Addendum #1 6/2/2020
Newton Place PENQUIS Grandview Ave., Bangor

Reference Architectural Bidding Documents dated April 16, 2020

3 Pages, including (1) SK.

SK-001

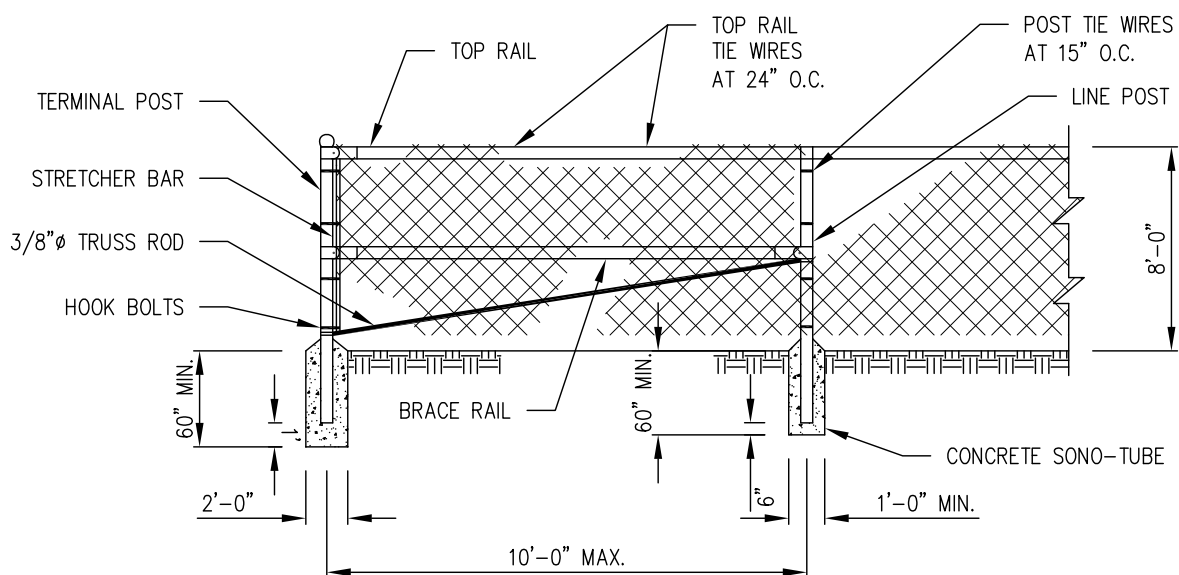
11. Drawing **C10**,
 - a. Chain Link fence details, Add: See attached SK-001 for revisions.
 - b. Chain link fence details, Add: a 3 ft wide side door to the dumpster enclosure for accessibility.
